Access Compliance Report

Public Rights-of-Way

(Pedestrian Signals)

Intersection ID: N/A	Main Street:	Cross Street: N/A	Location: N/A
ADA ID: 45908594A644	Signal Type: One Push Button-Non APS	Overall Compliance: No	Severity Score: BTN 1: N/A BTN 2: N/A No BTN: N/A
Codes/Mitigation Info/Possible Solution		Field Measurements/Component Compliance

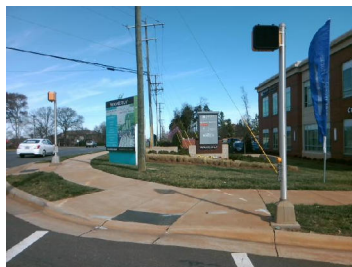
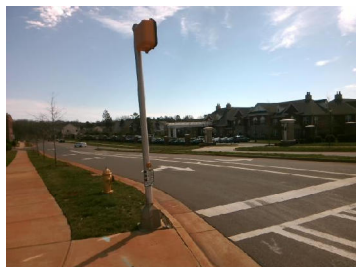
PROW/ADA: TMUTCD 4e.08, R404.7.2

N/A	B 1 Clear Xing Direction?	Yes	N/A	B 2 Clear Xing Direction?	N/A
	B 1 Crossing Direction	To S		B 2 Crossing Direction	N/A
Yes	B 1 DistanceTo XWalk (in)	28.0	N/A	B 2 DistanceTo XWalk (in)	N/A
No	B 1 DistanceTo Curb (in)	6.0	N/A	B 2 DistanceTo Curb (in)	N/A
Yes	B 1 Diameter (in)	2.0	N/A	B 2 Diameter (in)	N/A

Possible Solutions: Replace Signal Push Button With APS Button on New Post. Remove & Relocate Sign.
